Woolworths Regional Distribution Centre

11 Warren Road, Warnervale
NSW 2259

Access Review – DA 3 (Final)

24 March 2022

TITLE:
PROPOSED TRUCK WASH AND
MAINTENANCE FACILITY

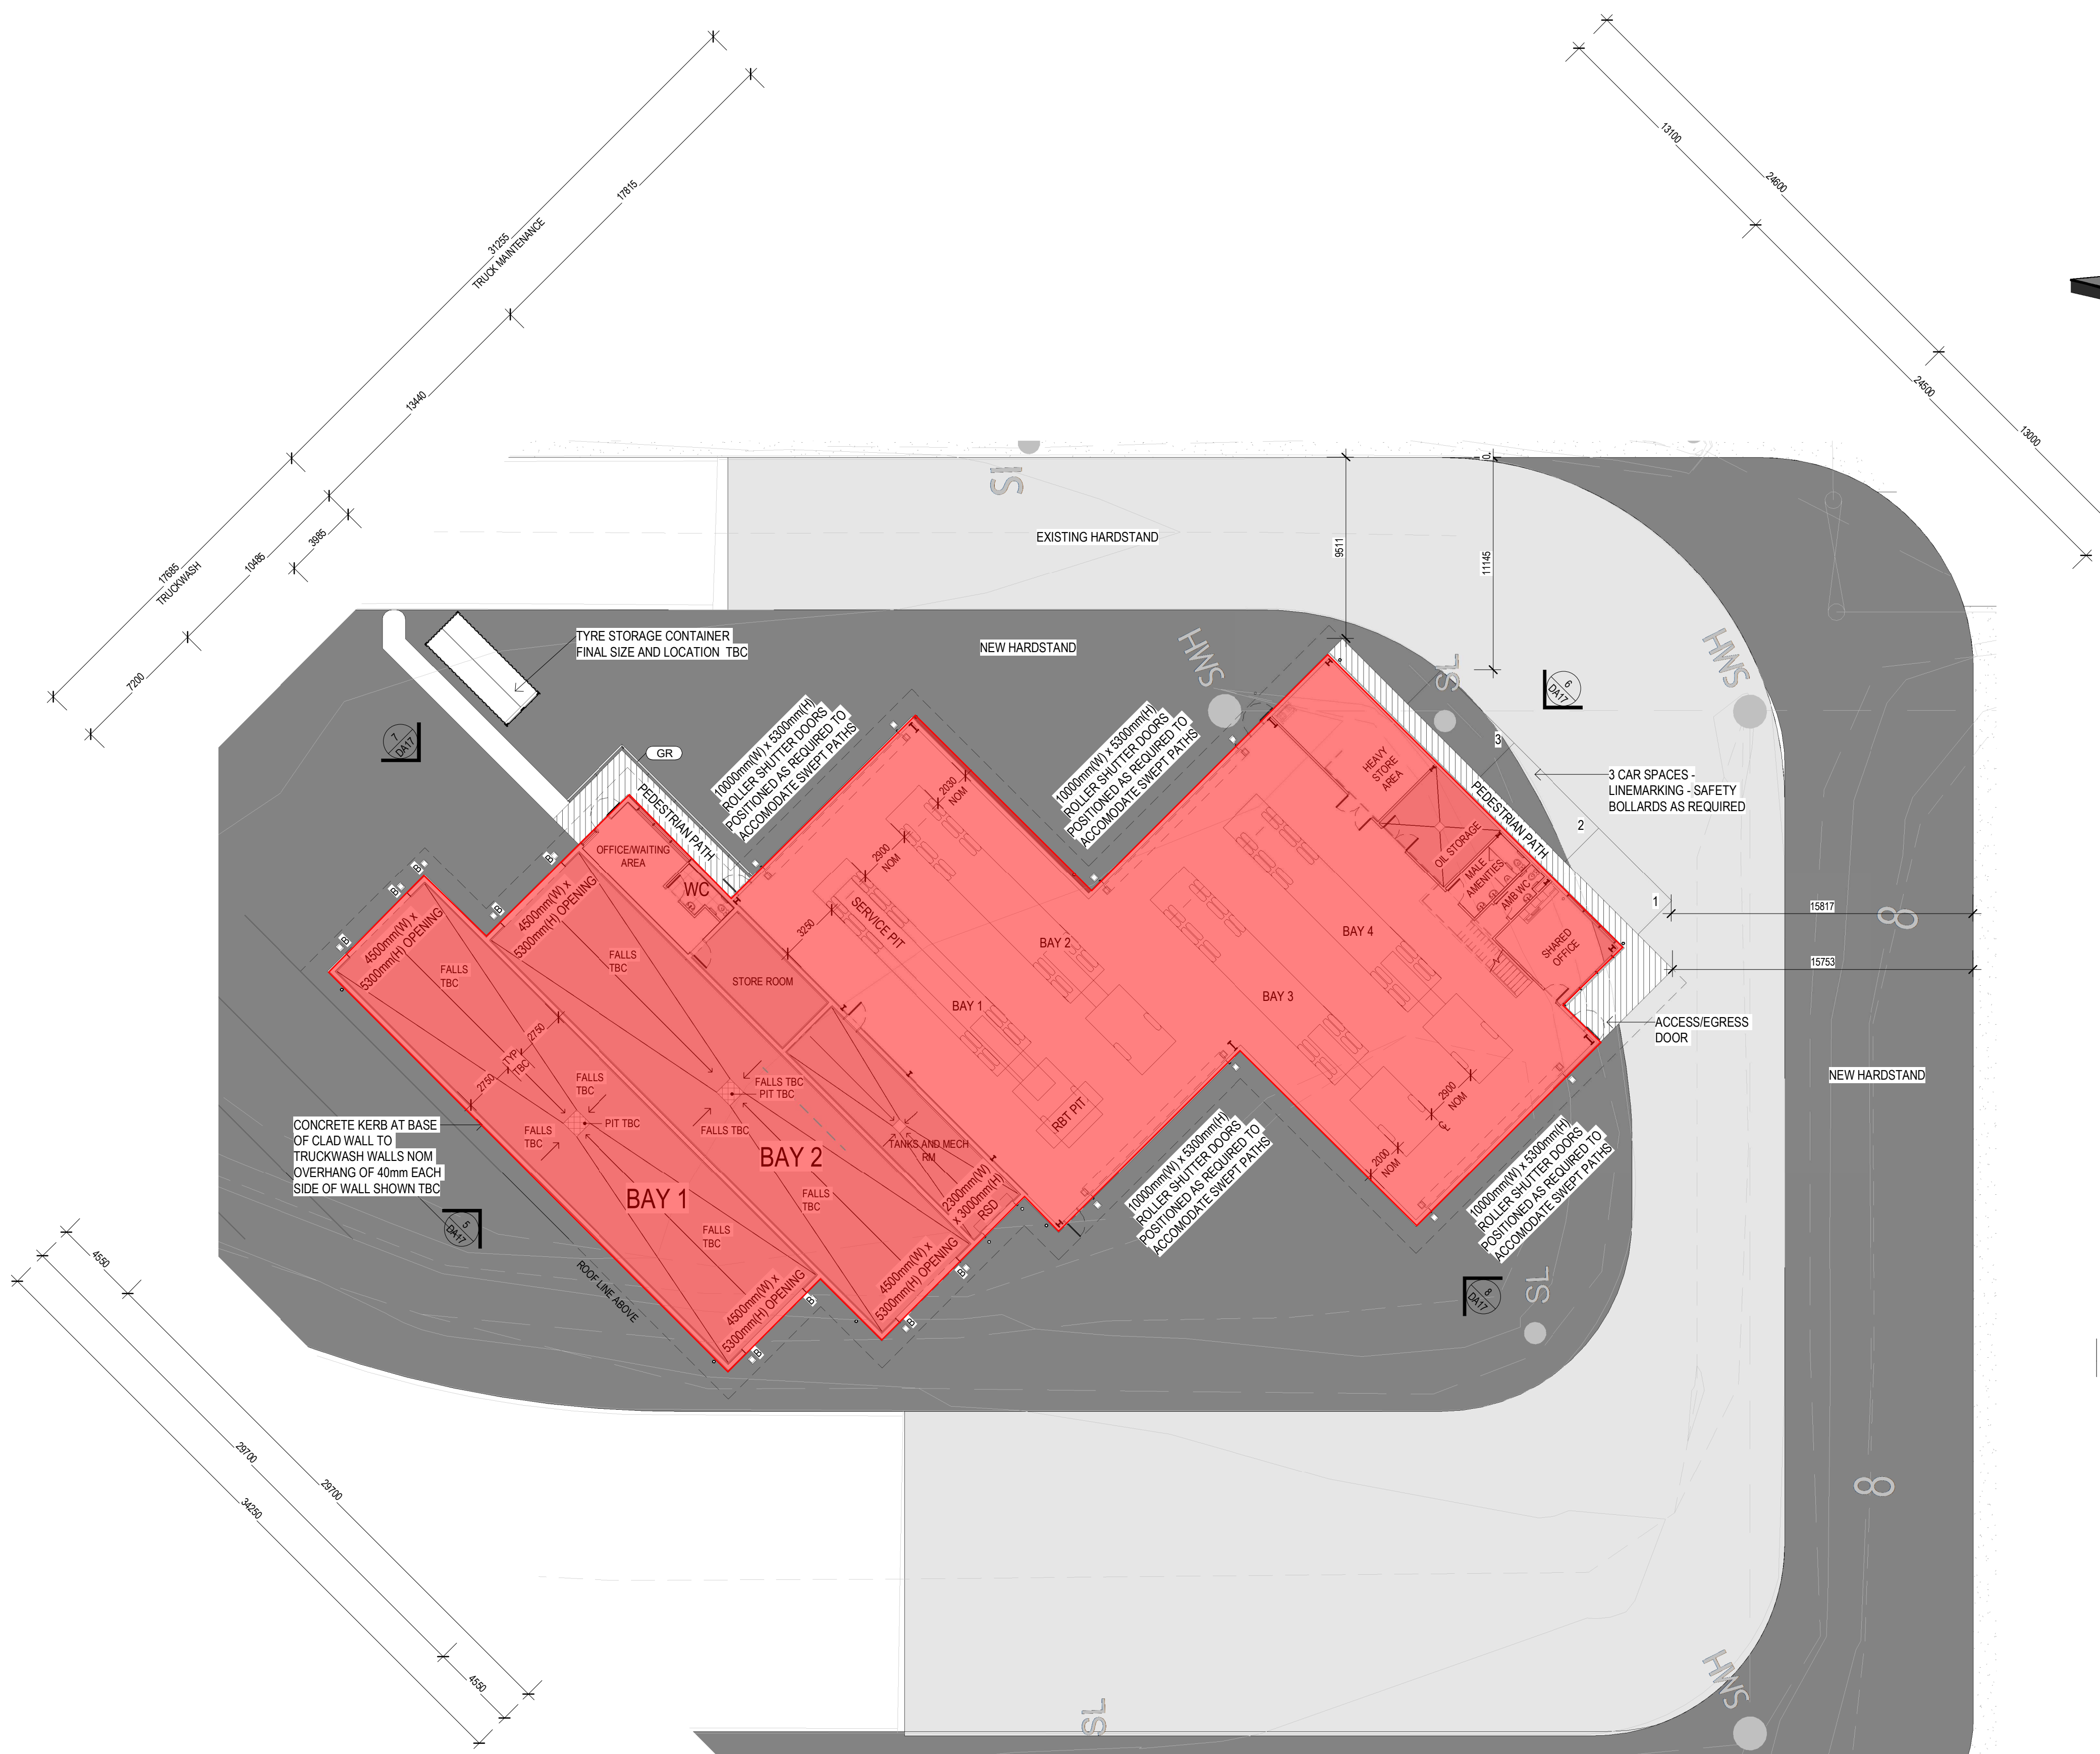
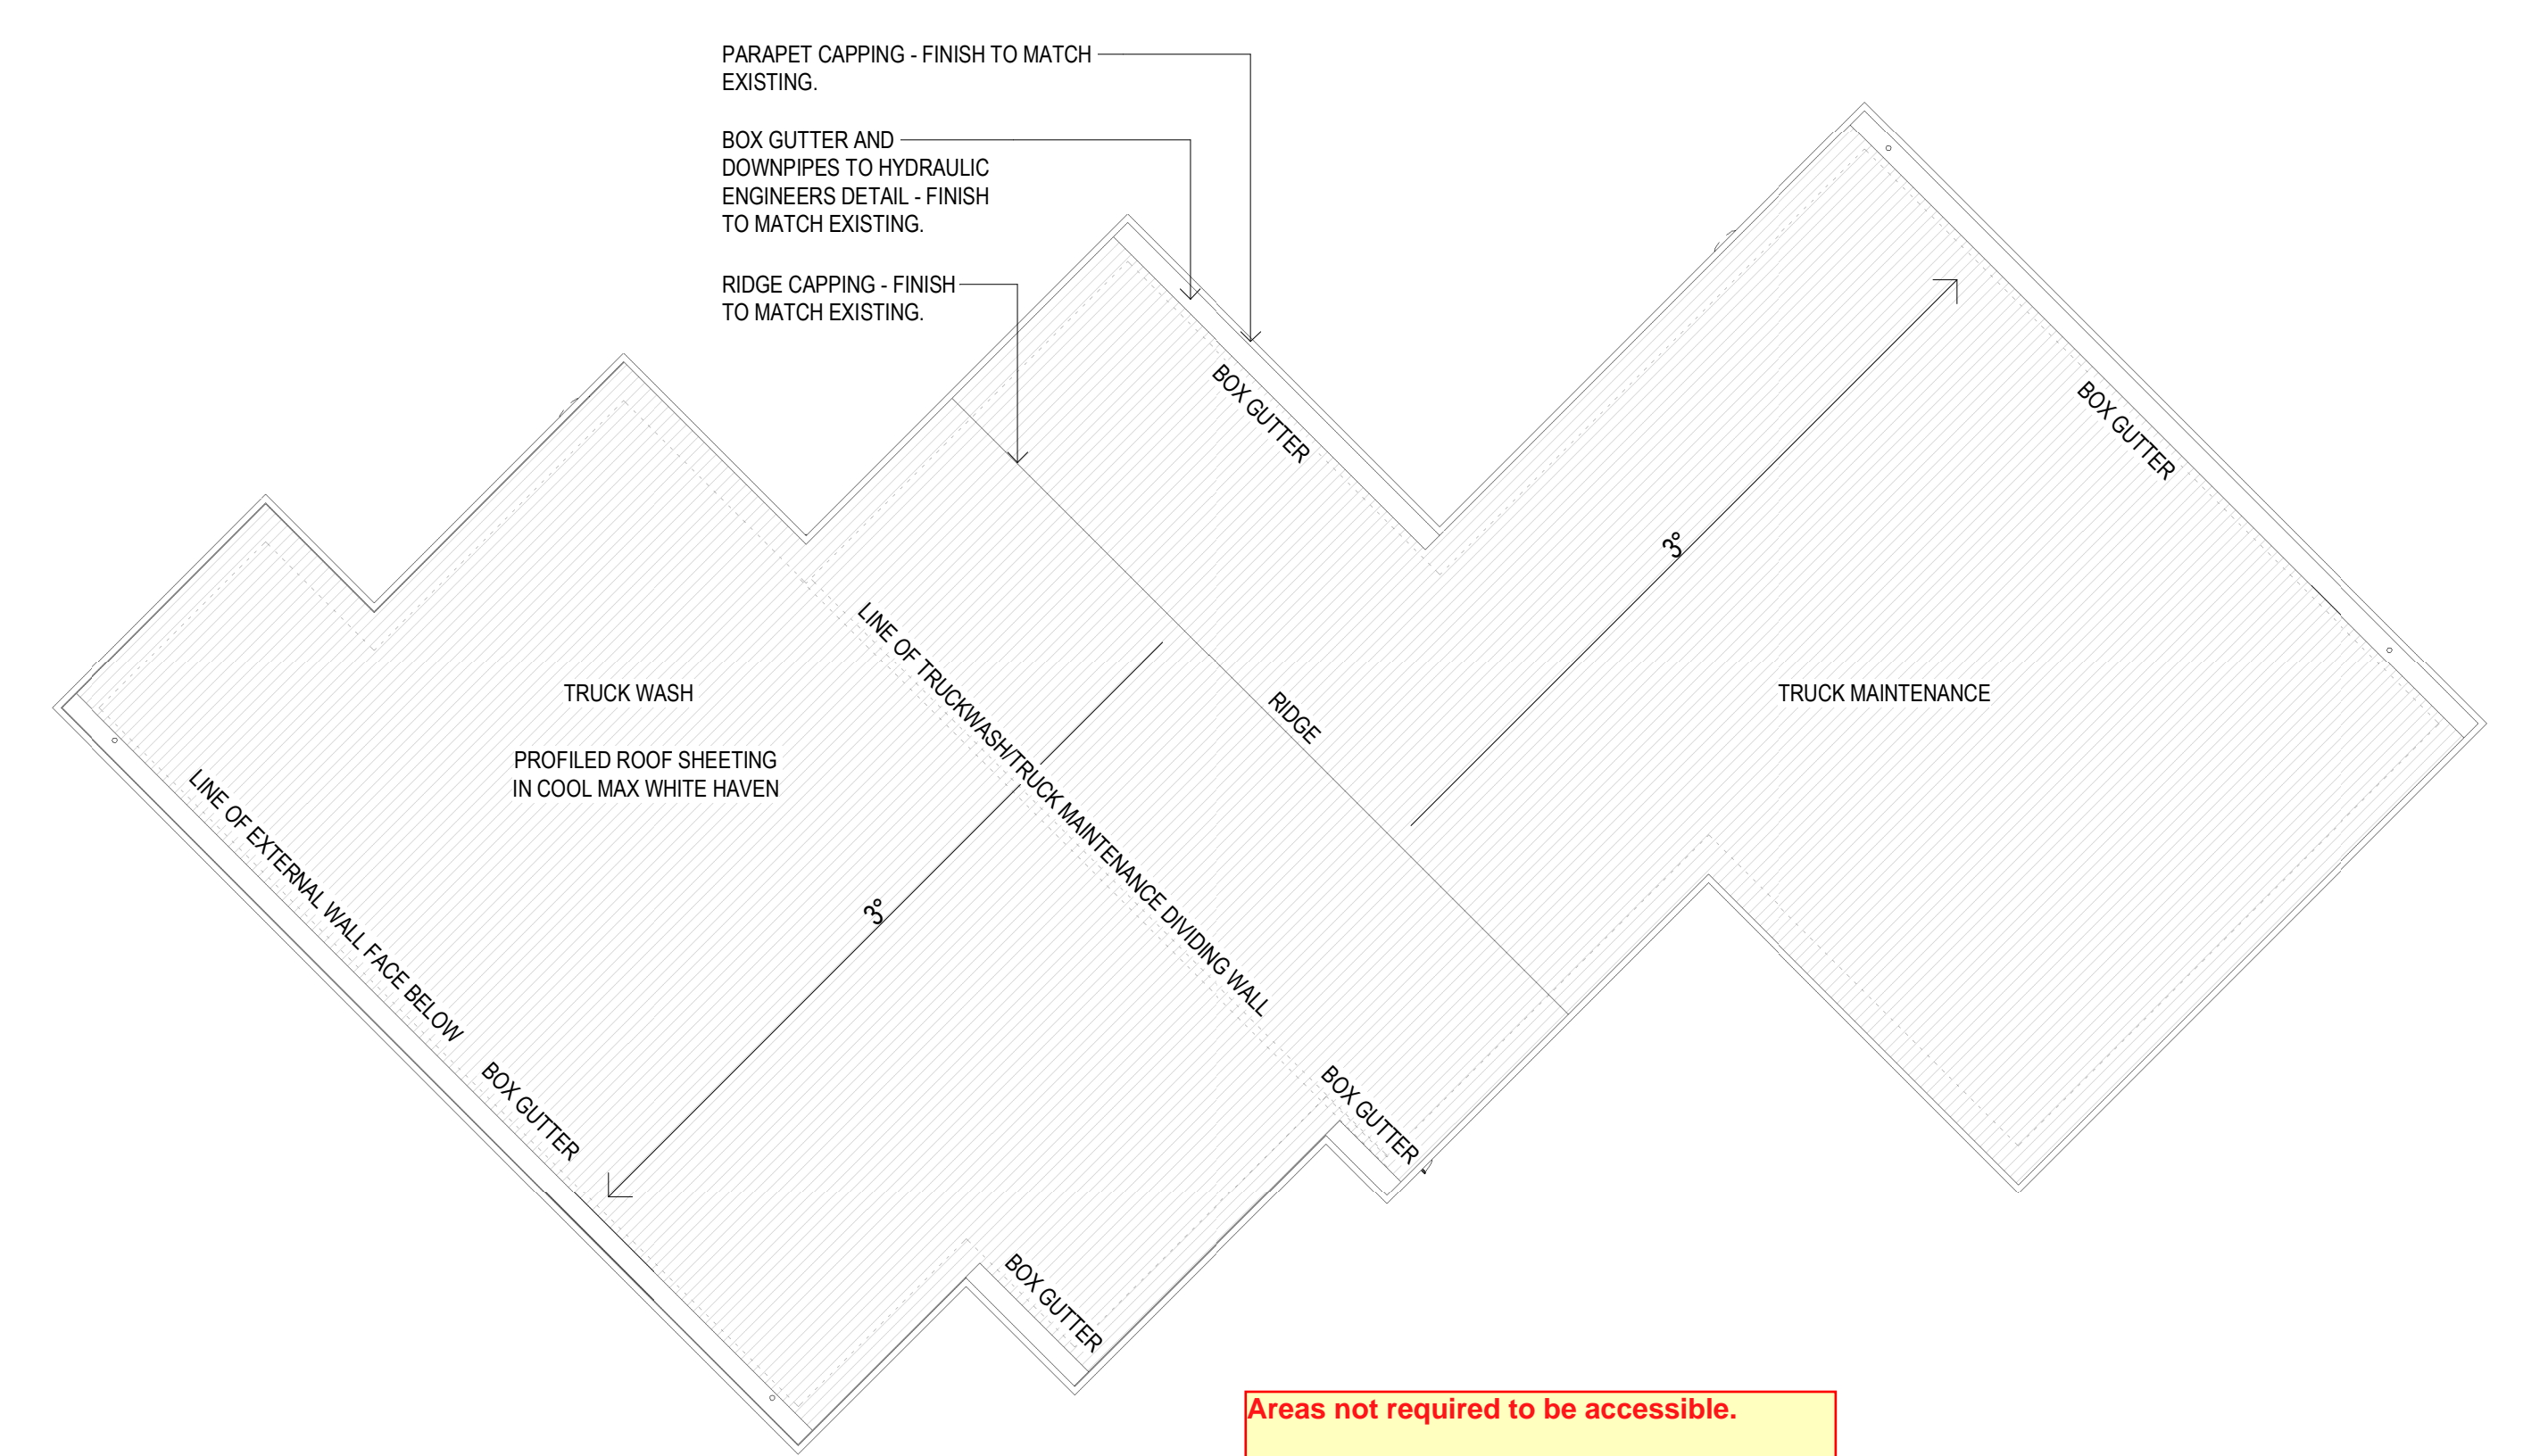
Areas not required to be accessible.
BCA D3.4 Exemption is applicable for areas that poses the health and safety risks for persons with disability, or where access is inappropriate because of the particular purpose and use of the area.
Due to the particular use of these areas being storage and distribution, and the health and safety risks it poses for persons with disability, it is noted access is limited to the green zone and the red zones can be D3.4 exempt.
Consult PCA also.

fully accessible areas for staff visitors would need to be escorted in these areas

non-accessible - unsafe work environment / no safe paths of travel
